SUNDRY NOTICES AND REPORTS ON WELLS
Do not use this form for proposals to drill or to re-enter an abandoned well. Use form 3160-3 (APD) for such proposals.

8. Well Name and No.
BILBREY 34 FED 1

9. API Well No.
30-025-31120

Permanent Abandonment of Federal Wells
Conditions of Approval (LPC Habitat)

Bilbrey 34 Fed #1

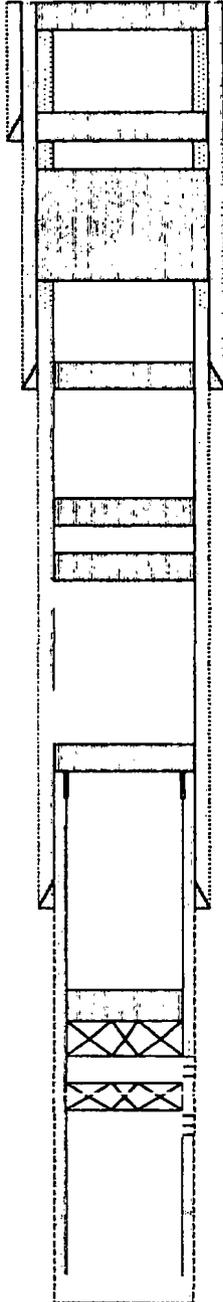
- MIRU. ND well head, NU BOP. POH w/ tbg.
- Tag existing plug @ 14,570' ¹⁴¹⁸⁷
- Set 4 1/2" CIBP @ 14,120' Circ hole w/ MLF. Pressure test csg. Spot 25 sx cmt @ 14,120-14,000' ^{14187-13 947.}
Add plug from 12030-11750 (4 1/2" shoe, T/wc) woc tag
- Spot 20 sx cmt @ 11,735-11,635' WOC & Tag. ^{11525 (T/liner)}
- Spot 30 sx cmt @ 9050-8900' ^{8575 (DVT) woc tag}
- Spot 25 sx cmt @ 5500-5400' ^{5350 (spacer)}
- Spot 25 sx cmt @ 4700-4600' WOC & Tag. (9 5/8" Shoe) ^{4550. Add 4220-3590 woc tag (Salt)}
- Perf & Sqz 285 sx cmt @ 3445-4700' WOC & Tag (R-111-P & DV Tool) ^{3580 sqz cmt 950. woc tag}
- Perf & Sqz 25 sx cmt @ 815-715' WOC & Tag (13 3/8" Shoe)
- Perf & Sqz 25 sx cmt @ 60' to surface.
- Cut off well head, verify cmt to surface, weld on Below Ground Dry Hole Marker.

9. Perf & Sqz 25 sx cmt @ 60' to surface.

8. Perf & Sqz 25 sx cmt 815-715'. WOC & Tag (13 3/8" Shoe)

7. Perf & Sqz 285 sx cmt @ 3415-1700'. WOC & Tag. (R-111-P & DV Tool)

6. Spot 25 sx cmt @ 4700-4500'. WOC & Tag. (9 5/8" Shoe)

5. Spot 25 sx cmt @ 5500-5400'.

4. Spot 30 sx cmt @ 9050-8800'.

3. Spot 20 sx cmt @ 11,735-11,635' WOC & Tag.

2. Set 4 1/2" CIBP @ 14,120'. Circ hole w/ MLF. Pressure test

csg. Spot 25 sx cmt @ 14,120-14,000'.

1. Tag existing plug @ 14,570'.
